3d Community Church

659 Graham Rd Sanford, NC

12/18/25

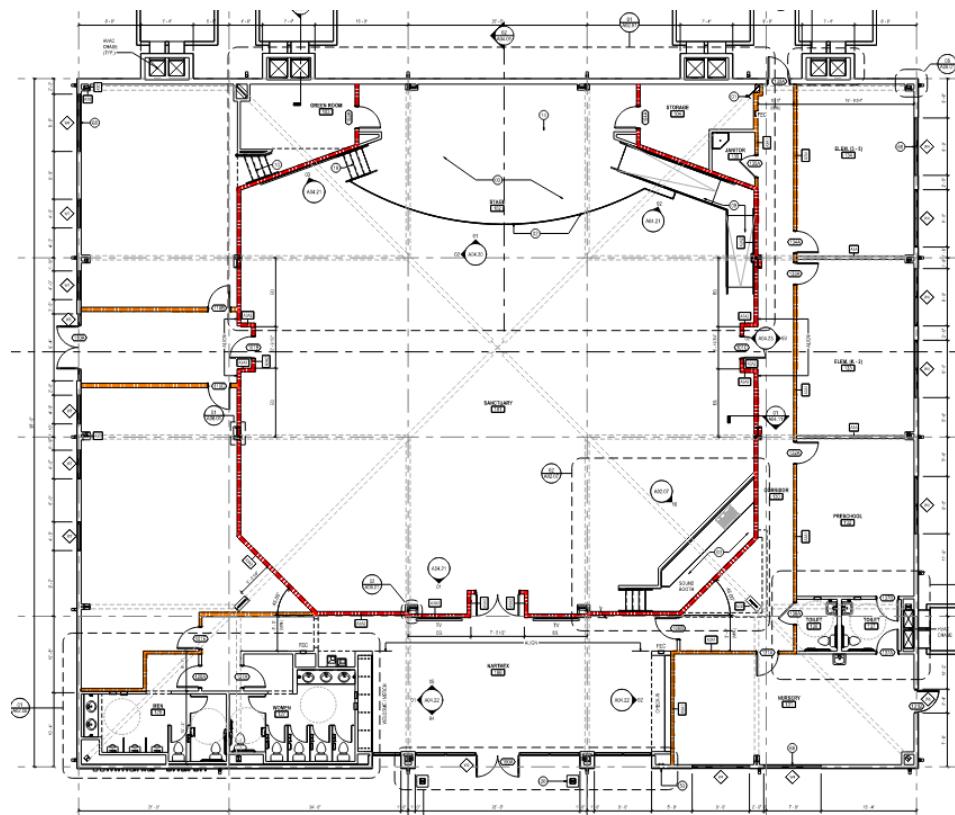
General contractor shall extend the one and two-hour fire rated wall framing and sheetrock tight to the roof insulation/tarp system. Apply fire caulk at the top of sheetrock. Allow deflection at the roof structure. — Follow UL Designs UL419 and V449.

Provide top of wall condition at rated walls indicated in red and orange below.

Hilti Detail CJ-D-0008 is good for 1, 2 and 3 layers of Sheetrock as well.

This includes for the 2 hour fire wall one layer on one side and three layers at the other side.
